DOOSAN	Design Change Notice UPPER TRISHULI-1 HEP (216MW)	DCN No. **DCN-23-C-014** GRADE : A PAGE: 1 OF 1

REFERENCE DOCUMENT NO.	REV	REMARKS / TITLE
UT1-C-040-CVL-DG-55001	0G	Layout Drawing of Air Vent Tunnel for Surge Tank

Rev.0F	Rev.0G
PLAN OF AIR VENT TUNNEL FOR SURGE TANK 1:1000	PLAN OF AIR VENT TUNNEL FOR SURGE TANK 1:1000

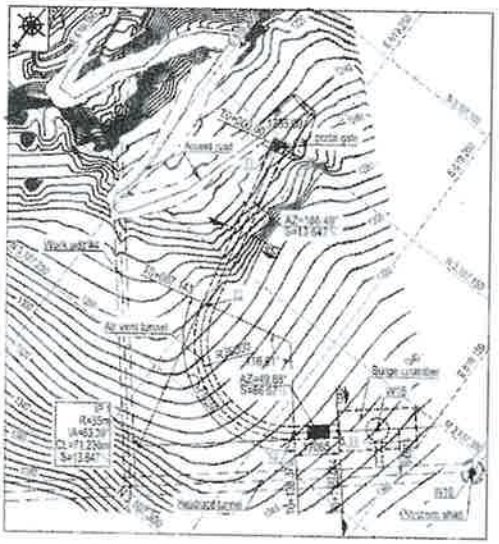
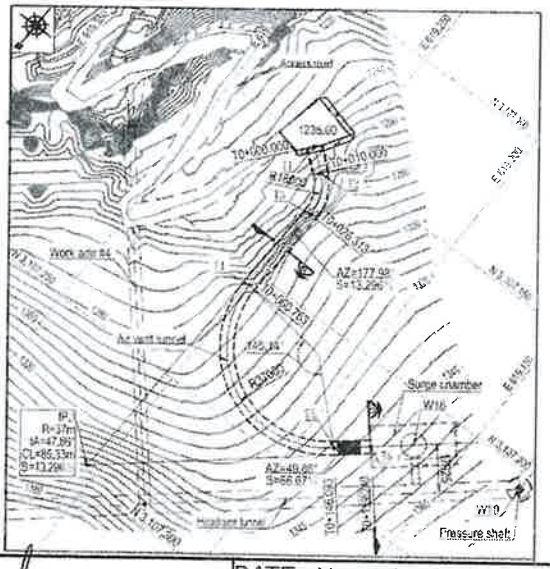
As per the present Site Location Condition of Air Vent Tunnel for Surge Tank, which was found unfavorable due to the Exposed Rock in Portal Area. So, to avoid the Rock Mass Failure, EPC Contractor Proposes for the Change in Design for Plan and Layout changing the alignment of Layout Plan based on site Condition.

ENGINEERING DESCRIPTION : PROPOSED CHANGED ACCEPTED

CHANGED APPROVED YES ☐ WITH COMMENT ☒ DISAPPROVED ☐

THE REDESIGN IS THE RESPONSABILITY OF THE EPC CONTRACTOR. ALL APPLICABLE DESIGN DOCUMENTS SHALL BE REVISED AND RESUBMITTED ACCORDINGLY
